## HISTORIC AND DESIGN REVIEW COMMISSION

July 06, 2018

**HDRC CASE NO:** 2018-305  
**ADDRESS:** 214 MUNCEY  
**LEGAL DESCRIPTION:** NCB 1665 BLK 1 LOT N 45 FT OF 19&20  
**ZONING:** R-6 H  
**CITY COUNCIL DIST.:** 2  
**DISTRICT:** Dignowity Hill Historic District  
**APPLICANT:** Dennis Adams Mengmeng Wang  
**OWNER:** Dennis Adams Mengmeng Wang  
**TYPE OF WORK:** Rear yard fence (corrugated metal); driveway approach widening  
**APPLICATION RECEIVED:** June 15, 2018  
**60-DAY REVIEW:** August 14, 2018

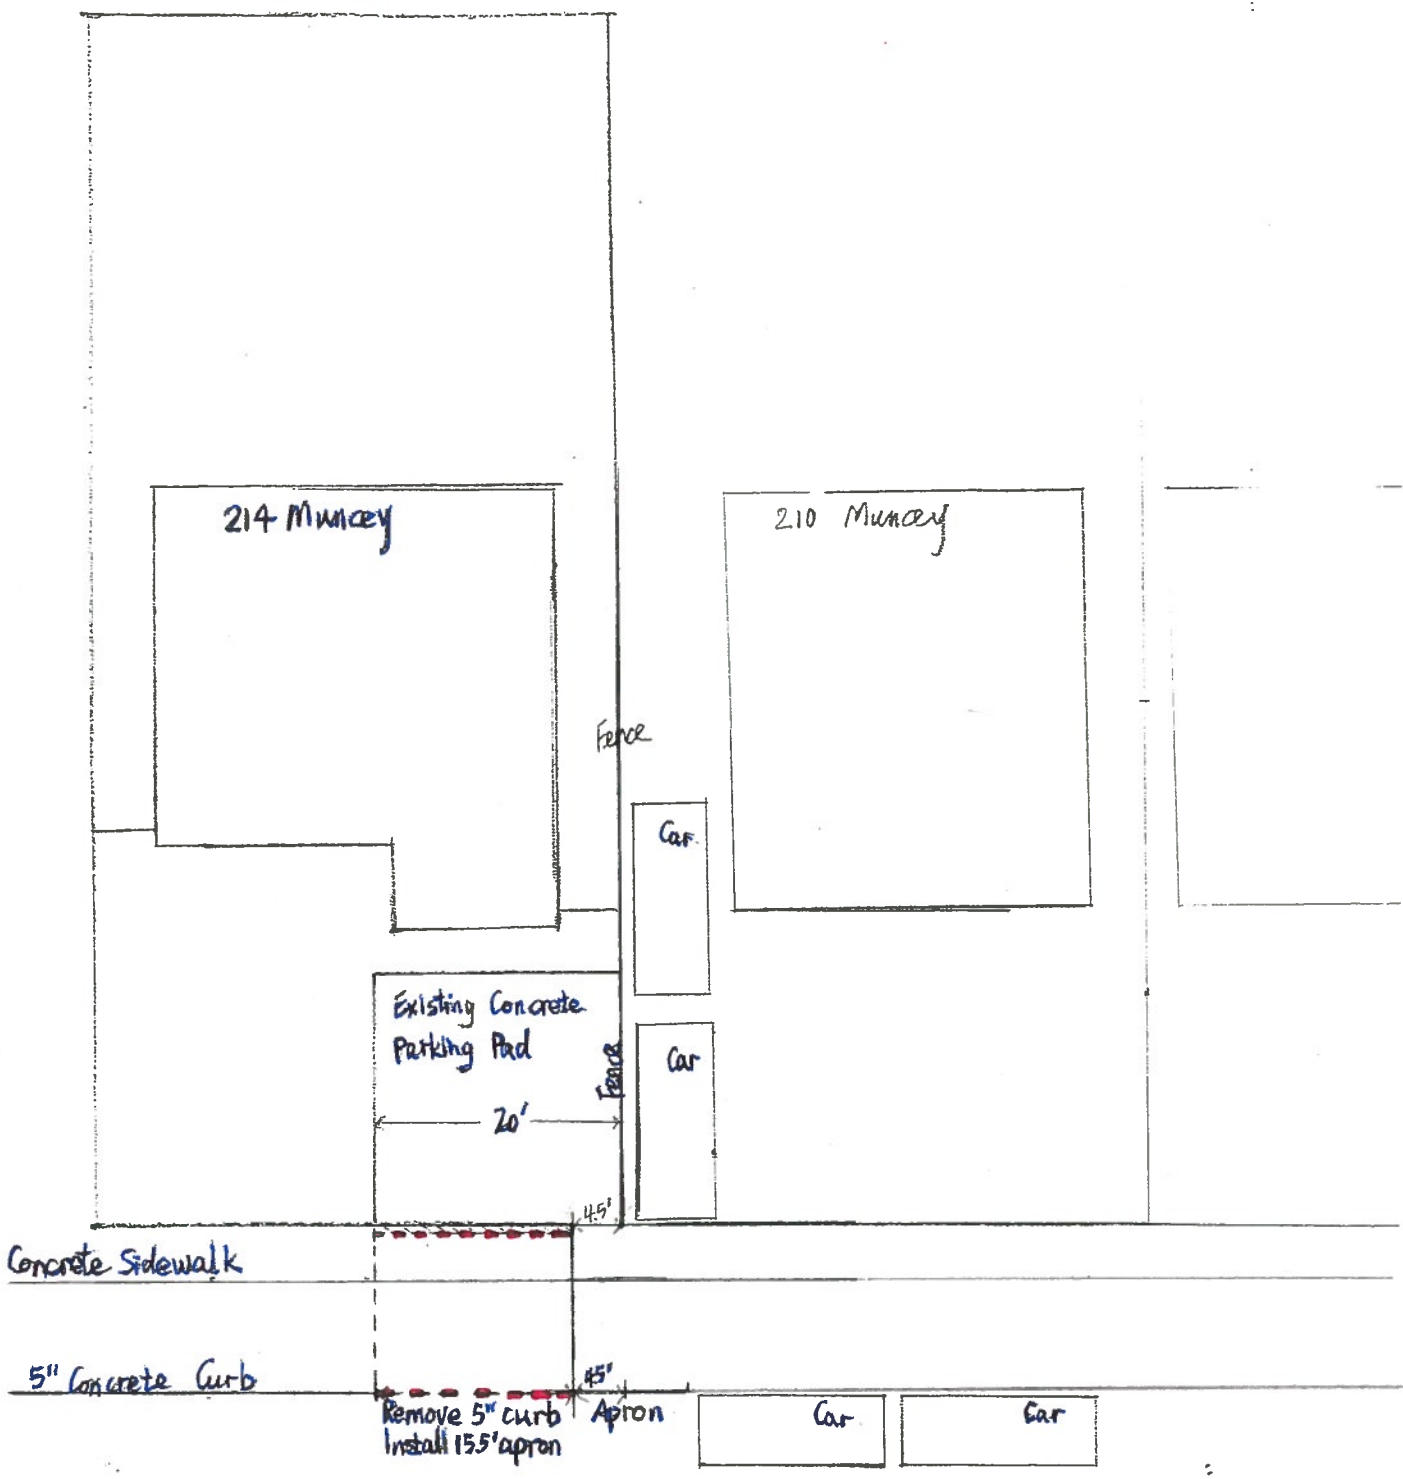
- b. SHUTTERS – The applicant proposed to install faux shutters on the front windows. Per the Guidelines, shutters should only be installed where they existed historically and should be operable or appear to be operable. Staff does not find the proposed shutters appropriate.

- c. FENCE - The applicant proposed to install rear privacy fencing featuring wood framing with metal panels. Per the Guidelines, metal panels are prohibited as fencing material. Staff finds that wood privacy fencing without metal panels, at 6 ft in height, and located behind the front façade plane is eligible for administrative approval.

- d. DRIVEWAY – The applicant is requesting to install 15.5 ft in width of additional driveway apron to meet the existing 20 ft wide parking pad. Between 214 Muncey and its neighboring property, this installation would create a condition where approximately a 25 ft wide apron would meet a 20 ft wide parking pad and a 7ft wide driveway. Per the Guidelines, driveways in historic districts should not exceed 10 ft in width. Staff finds the proposed 15.5 – 25 ft wide apron not consistent with the Guidelines. Staff finds that the applicant may install an apron tapering up to 10 ft onto their own property without increasing the width of the shared existing apron – or the applicant may install a 10ft apron entirely separate from the shared existing apron.

- i. Staff does not recommend approval of the shutters based on finding b (withdrawn by applicant).
- ii. Staff does not recommend approval of the privacy fence proposed based on finding c. A rear privacy fence featuring wood construction without metal panels is eligible for administrative approval.
- iii. Staff does not recommend approval of the driveway as proposed. Staff recommends the applicant taper up to 10 ft from the existing shared apron – or install a 10 ft wide apron entirely separate from the shared existing apron.
